ALLEGHENY COUNTY HEALTH DEPARTMENT
Air Quality Program

**SUMMARY OF PUBLIC COMMENTS AND DEPARTMENT RESPONSES ON THE
PROPOSED STATE IMPLEMENTATION PLAN REVISION (NO. 90) FOR THE
ALLEGHENY COUNTY, PA NONATTAINMENT AREA, 2012 PM_{2.5} NAAQS**

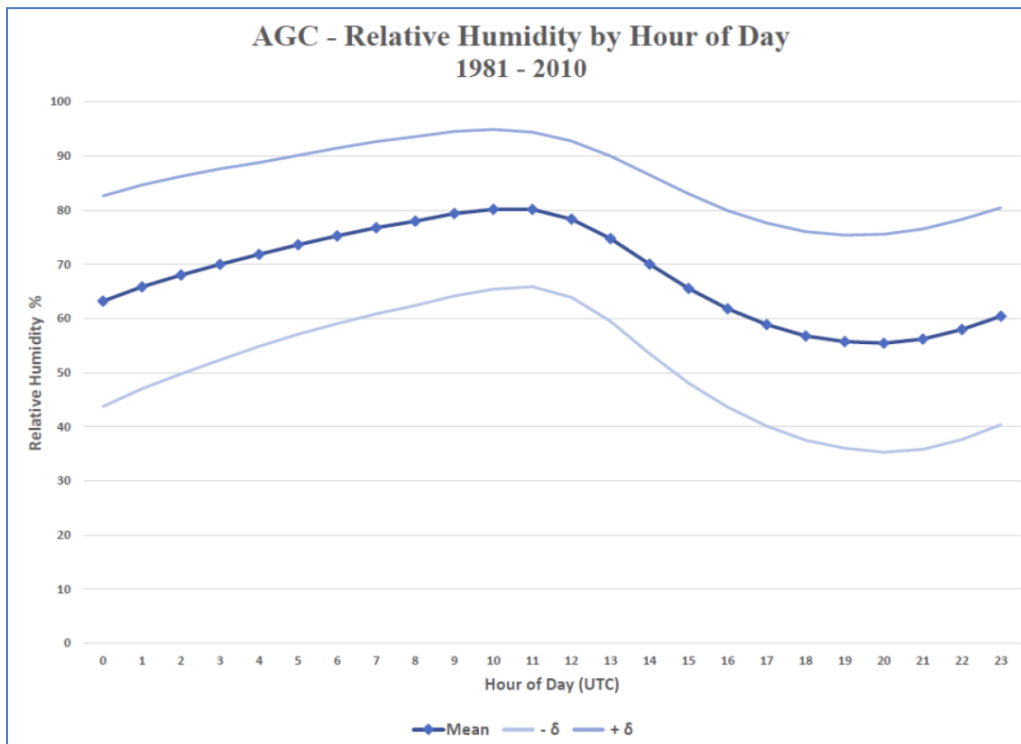
21. Comment: ACHD's modeling for the future year 2021 is flawed because it is based on unrepresentative meteorological conditions in the base year 2011, where there was an unusually high amount of annual precipitation. Only four years of the past 30 years had a greater amount of precipitation, and only one of them occurred after the base year (in 2018). The base year also had the second-lowest number of annual inversions (157) during the 2009-2018 period, and year 2012 is far more representative of normal temperature inversion conditions than was the year 2011. Additionally, ACHD is implicitly appealing to climate change to substantiate its use of unrepresentative meteorological conditions for the future year, which is not recommended by EPA's modeling guidance.

Response: Based on the implementation rule, one of three years (2011, 2012, or 2013) was to be selected as the base year. As mentioned in Problem Statement (Section 2) of the SIP and the CAMx Model Protocol (Appendix F.2), part of the basis for selecting year 2011 was that 2011 NEI included the best-reviewed emissions data and modeling platform, and the use of other years would have required additional interpolations or estimations of emissions.

Wind and pollution roses show that 2011 represents the conditions during the five-year weighted monitored base period of interest – 2009 through 2013 – quite well. Although surface temperature and precipitation during 2011 were above normal and the frequency of inversions was below average for the period, temperature and precipitation during 2011 were closer to more recent weather conditions in Allegheny County.

As for morning surface inversions, on a monthly basis, October and November 2011 measured some of the strongest inversions of all months of the five years examined. In fact October 2011 recorded the strongest average inversion for any month during the five years under consideration. For 24-hour projections, only the highest (top 10%) days per quarter are used for the attainment tests, so the total number of high days in a quarter is less important than the highest overall days. Furthermore, in the county, based on the previous ten years of measurements, fall has the strongest inversions, while being the season with the second deepest, second most persistent, and second most-frequent occurrence of inversions of any season. And, historically, autumn months are typically when inversion conditions produce the highest particle-pollution concentrations. Thus, when looking more closely at the monthly data, 2011 represent worst-case, short-term conditions as well as variability for meteorology seen over the 2009-2013 timeframe.

Additionally, the modeled impacts are not used directly for the attainment tests, as the PM_{2.5} design value projection approach uses the base and future year modeled results in a relative fashion to scale the observed base year timeframe monitored values. Any modeled under- or over-prediction is carried over from base to future year. The modeling showed good model performance for year 2011, and it's expected that 2012 or 2013 would show similar performance. Specific meteorological conditions are less critical for the demonstration than the model responses under the tested conditions.

Last, the mention of more recent years was intended as a broad look at representative meteorology over a longer timeframe, and 2011 was not selected as a meteorological year because of higher precipitation due to climate change.

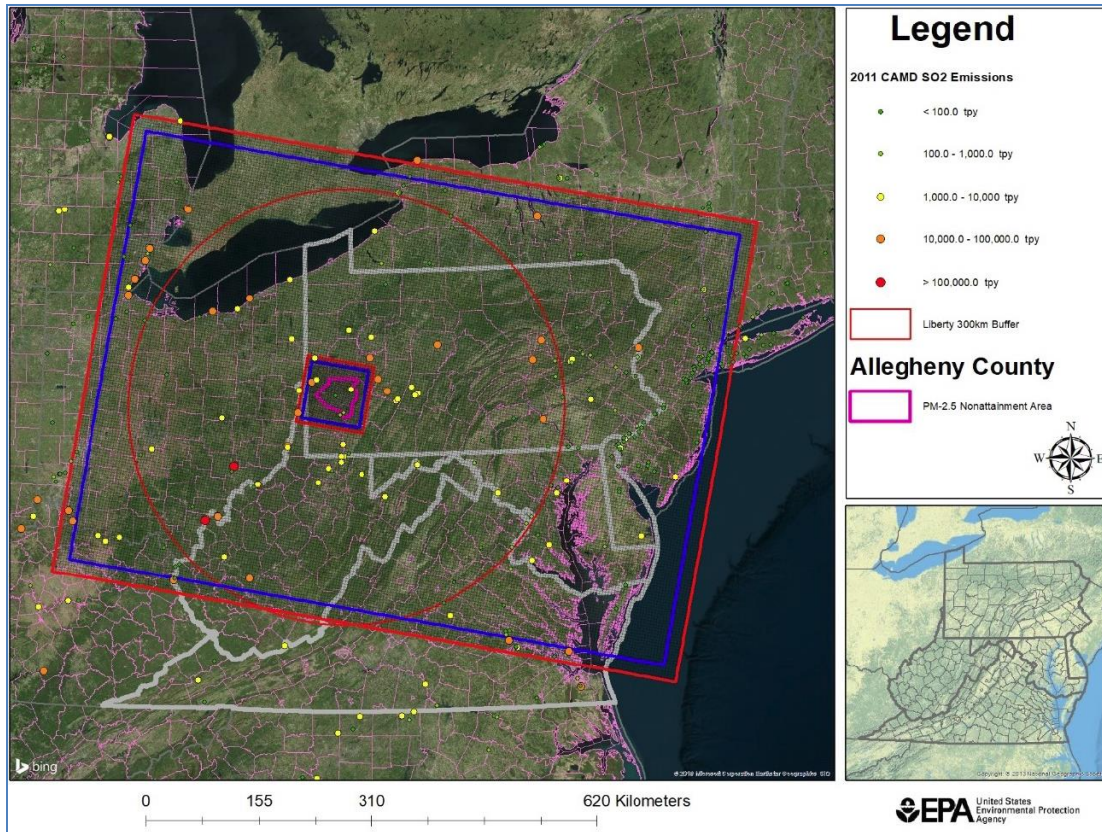
29. Comment: ACHD's use of a Local Area Analysis approach for the Liberty monitor is not consistent with EPA's procedures in the guidance document for attainment demonstrations for fine particulates. The purpose of a local area analysis is to supplement the results of the attainment test, not to replace the results. EPA recognizes that the application of a chemical transport grid model on a regional or local scale is the best tool available to judge the impacts of changes in future year emissions on concentrations (see Section 6.1.1 of the guidance). The CAMx model as configured for the SIP addressed local impacts by using the Plume-in-Grid (PiG) option, and ACHD's stated rationales for displacing the CAMx modeling are not justification for abandoning the CAMx results.

However, the most important factor concerns the modeled species apportionment with the CAMx modeling and MATS projections. As shown in the modeling documentation (see specifically Figure 2-6 in Appendix I.1), a large portion of the modeled excess was “other” component, which represents unspiciated primary PM_{2.5} that is not assigned to specific chemical compounds by the model. From the EPA methodology, and as built into the MATS software, other component is directly associated with monitored crustal component (or fine soil), calculated from concentrations of soil-related trace elements. However, the monitored excess species at Liberty are mostly carbons (see Appendix C) and not crustal component (or trace elements that might be lumped in with fine soil, such as iron). While the CAMx/PiG results are showing good overall performance for total PM_{2.5}, the model species mapping algorithms are assigning the incorrect species to the primary excess at Liberty.

Therefore, the modeled excess must be reassigned in order to correctly predict the Liberty concentrations. This is crucial to the future projections because a control that reduces primary PM_{2.5} emissions in the area will mostly scale down only the monitored crustal component when using the MATS software. This has little effect on the future design value, as crustal component is a very small portion of the monitored Liberty excess (see Figure 2.3 in Appendix C). A reduction in primary PM_{2.5} from a contributing source should realistically scale down the more prominent excess species such as carbons.

For the LAA, the solution to the species apportionment problem was to model local primary material (LPM) as a separate species with AERMOD, added to the CAMx results without LPM. LPM is the sum of all excess species, since AERMOD does not include chemistry. (The use of LPM also eliminates further error in the composition of species, focusing instead on just the magnitude of the total localized primary impacts.) The AERMOD results were then used to scale down the analogous monitored LPM (sum of excess monitored species), with the CAMx non-LPM results used to scale the regional species. The modeled local excess from AERMOD showed very good agreement with monitored local excess in base year (see Appendix G.3).

In terms of a simple analogy, the CAMx/PiG results generated an excess of four apples at Liberty, but the actual monitored excess showed an excess of four oranges. The LAA accounted for the excess by modeling four generic “fruits.” Even if additional modeling was not performed with AERMOD, additional recalculations would have been necessary to the CAMx output, as the MATS software does not allow for reapportionment of species.

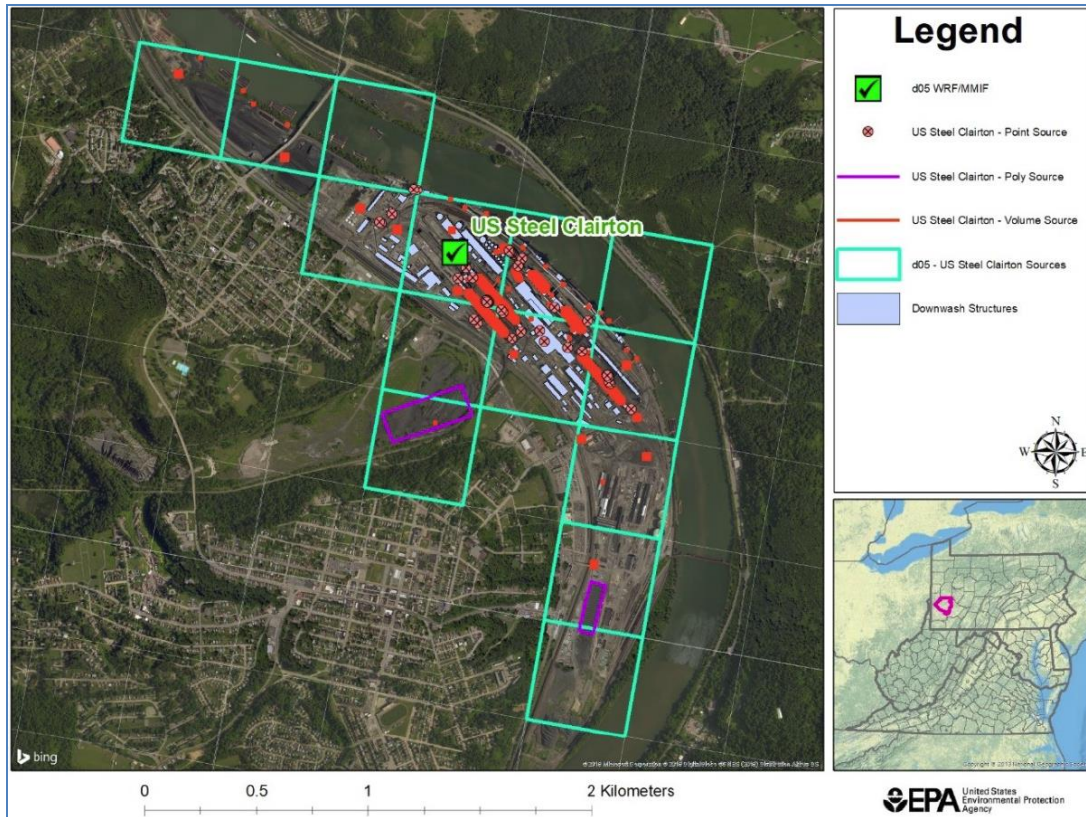
45. Comment: In Appendix I.1, Section 3.3.2. MATS Annual and 24-hr PM_{2.5} Projections in 4 km CAMx Domain: EPA compared the d03 (4 km CAMx) results from Table 3-8 to the 2017 PM_{2.5} design value spreadsheet available from EPA’s Air Trends website. For the annual PM_{2.5} NAAQS, the d03 grid appears to be predicting higher future concentrations for most of the monitors within the domain (i.e. the 2017 monitor design values are already lower than the projected 2021 values). Similarly, for the 24-hour PM_{2.5} NAAQS, almost all projected values are higher than the 2017 monitor design values. This result seems to indicate the model may be over-predicting actual PM_{2.5} design values within the domain, making it more likely Allegheny County will attain the PM_{2.5} NAAQS by its statutory attainment date.

Response: ACHD acknowledges the findings. The overestimation is due mainly to the use of the ERTAC 2.4L2 emissions projections for SO₂ and NO_x from coal-fired power plants. The ERTAC 2.4L2 emissions for 2021 were essentially a 2015 inventory for power plants, with uncontrolled plants also adjusted for potential higher demand in 2021. Many deactivations and controls in place since 2015 and expected through 2021 have not been

accounted for in the modeled results. The regional modeled results can be considered to be conservative (overestimated) for actual future PM_{2.5} concentrations.
